ATTACHMENT 1

CHANGES TO TECHNICAL SPECIFICATIONS

ATTACHMENT 2

CHANGES TO FSAR SECTIONS

CPSES/FSAR  
TABLE 6.2.4-3  
(Sheet 1 of 14)

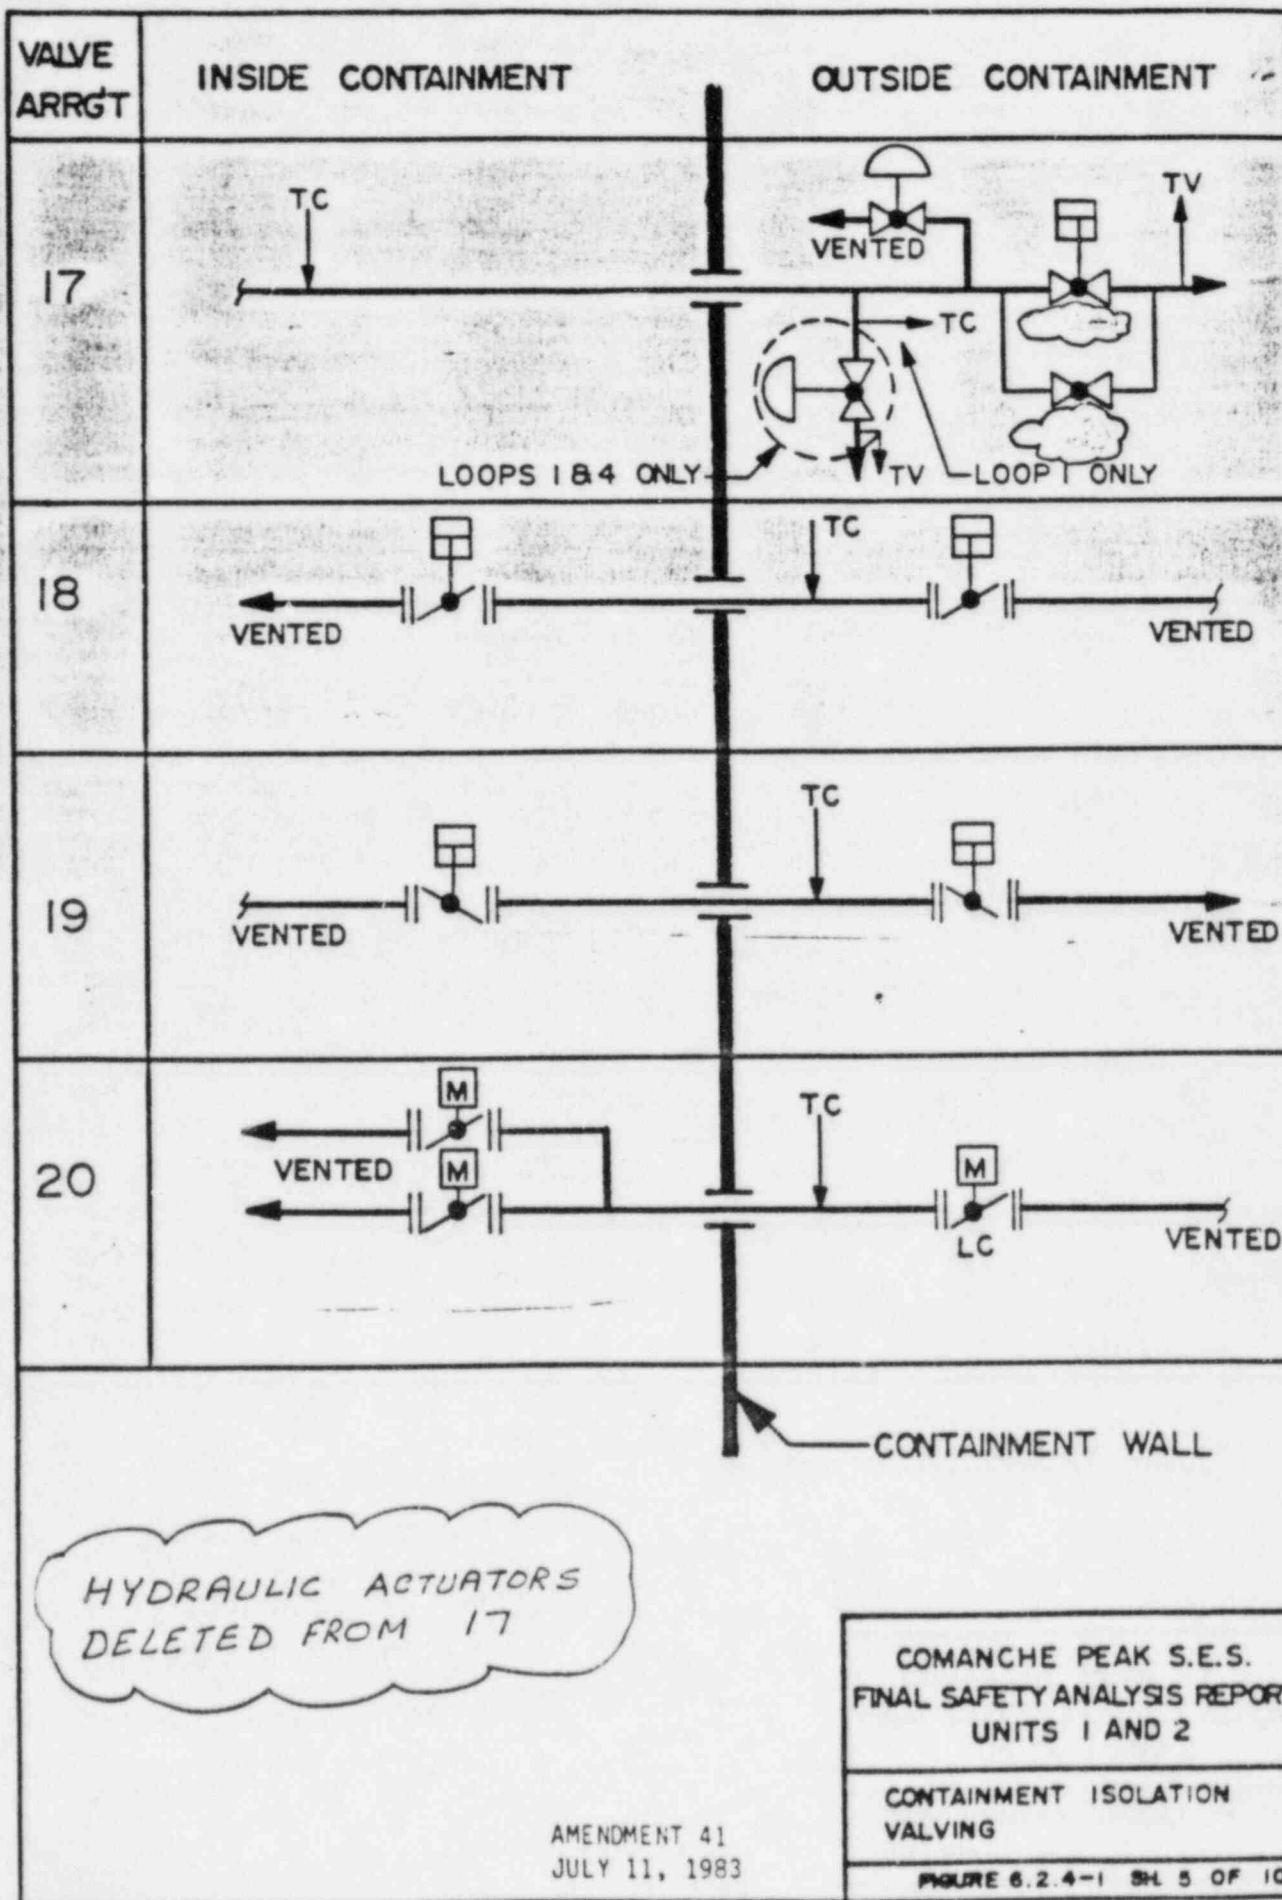
Item	Containment Isolation Signal	Valve Position			Valve Power Failure	Valve Closure Time (Sec.)	Power Source	Remarks
		Normal	Shutdown	Post-Accident				
1	Steam Line Isolation	Opened	Closed	Closed	Closed	5	-	
2	Steam Line Isolation	Closed	Closed	Closed	Closed	⑤ <sup>2</sup> N/A	-	Isolation Main Steam By-Pass Valve
3	Steam Line Isolation	Opened	Closed	Closed	Closed	5	-	
4	-	Closed	Opened	Opened	Opened	N/A	-	
5	-	Closed	Closed	Opened/Modulation	Closed	N/A	-	
6	Steam Line Isolation	Opened	Closed	Closed	Closed	5	-	
7	Steam Line Isolation	Closed	Closed	Closed	Closed	⑤ <sup>2</sup> N/A	-	Isolation Main Steam By-Pass Valve
8	Steam Line Isolation	Opened	Closed	Closed	Closed	5	-	
9	-	Closed	Closed	Opened/Modulation	Closed	N/A	-	
10	Steam Line Isolation	Opened	Closed	Closed	Closed	5	-

REF DWG 2.323 MI-0202 REV CP-5

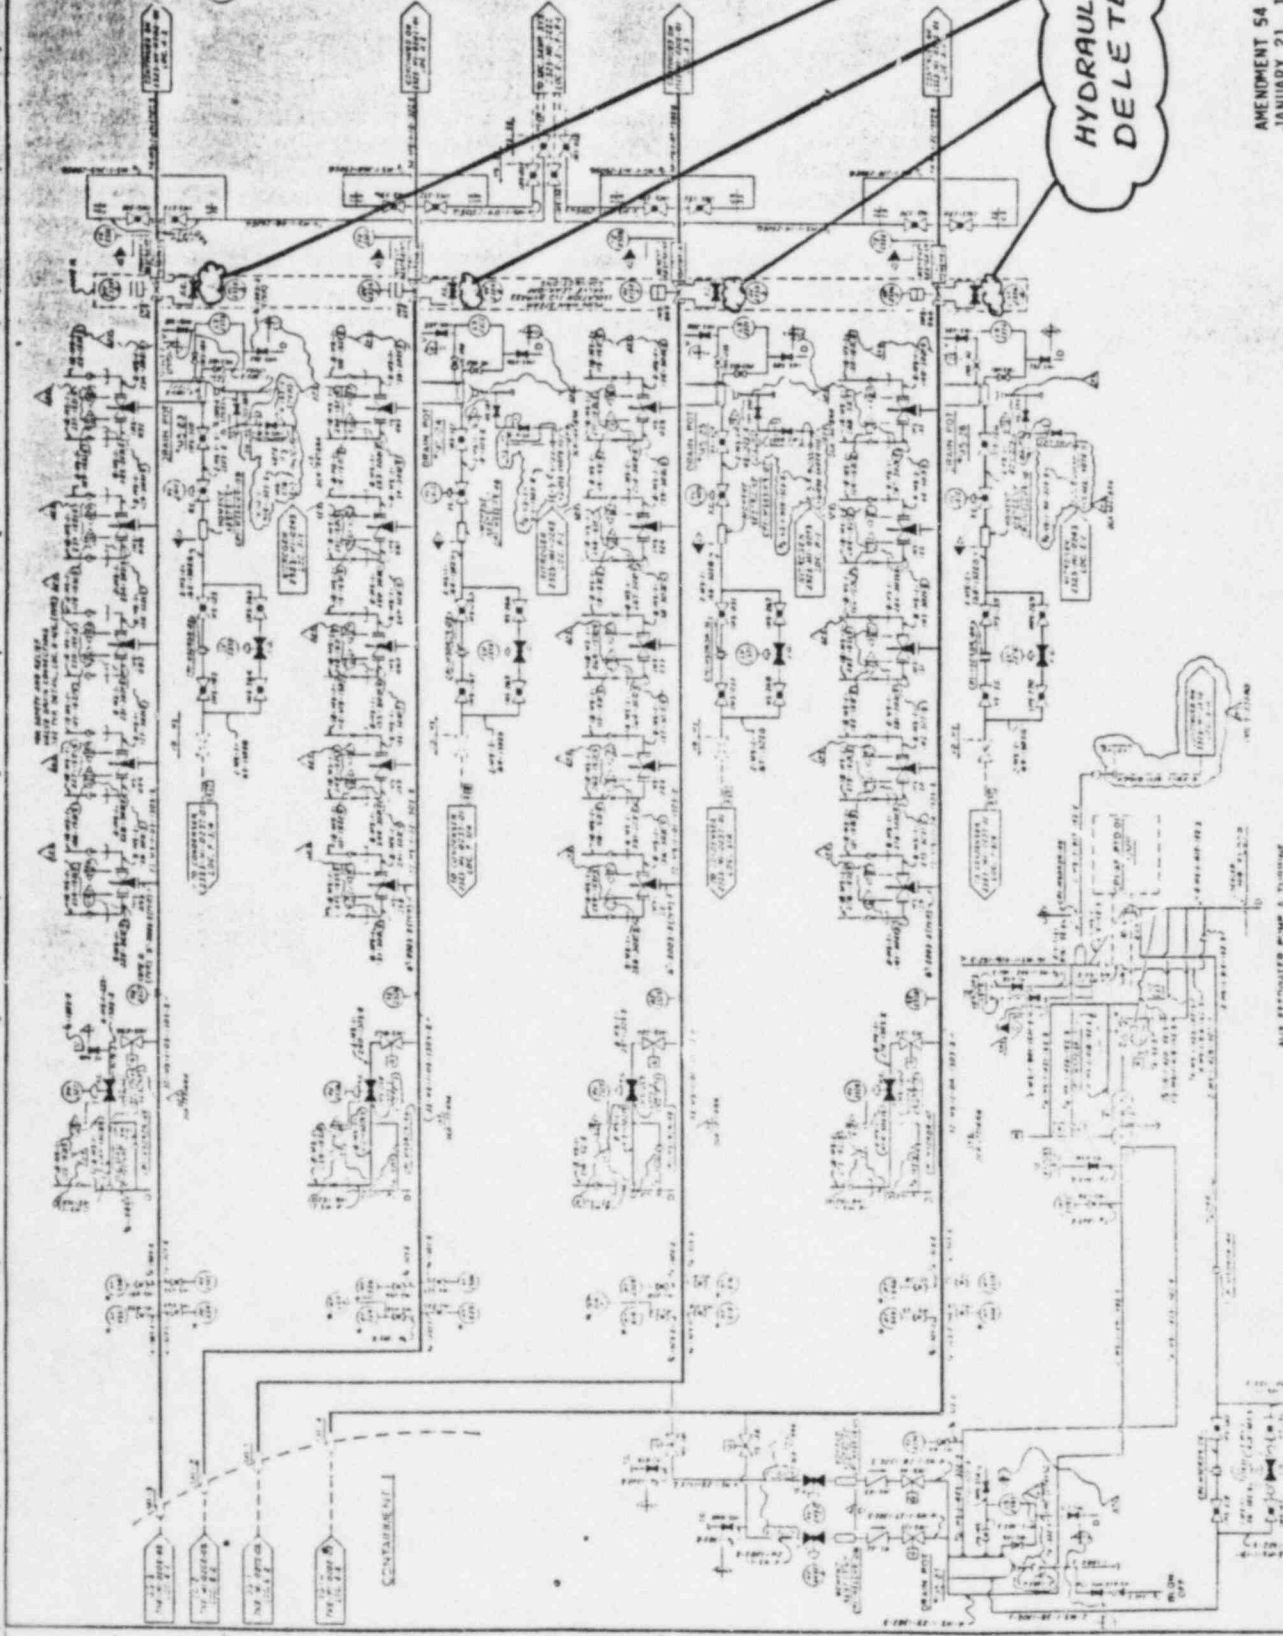
HYDRAULIC ACTUATORS  
DELETED

The Main Steam Isolation Valve (MSIV) Bypass valves were converted from automatic to manual. The hydraulic actuators were deleted and handwhals installed. The valves are capable of being locked in position.
